## Sent: 17/03/2020 9:03:42 PM Subject: DA 2020/0201 10 Willandra Road Beacon Hill 2100

## Please find attached my comments on the DA2020/0201

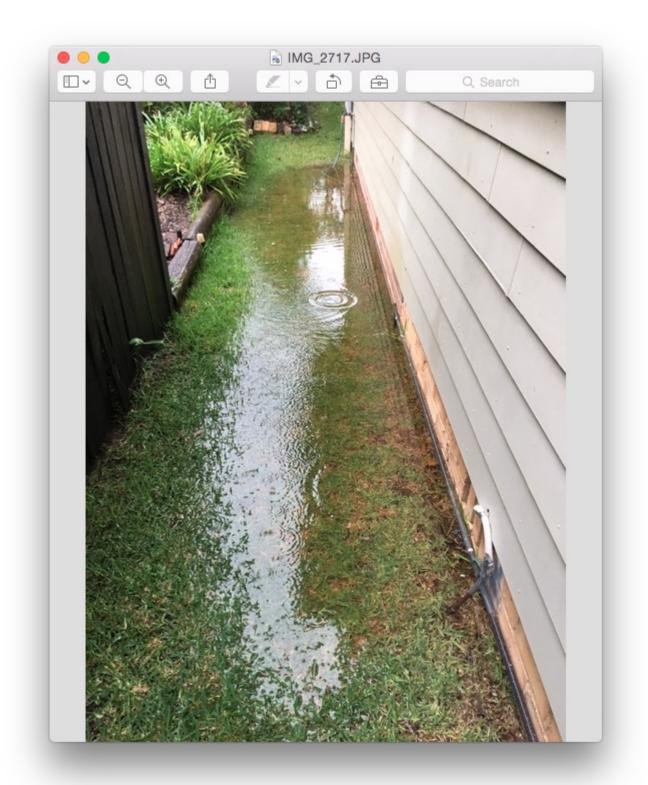
The location of the proposed development just 1 metre from the common boundary and its height mean that the current view of open green space along the common boundary will be replaced by a dark metal wall.

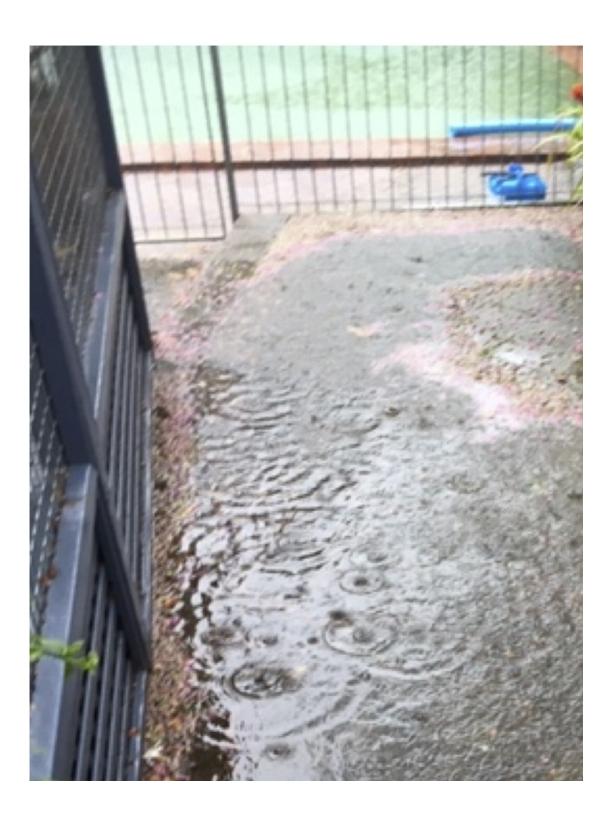
The 1m distance from the common boundary removes the opportunity for a screen.
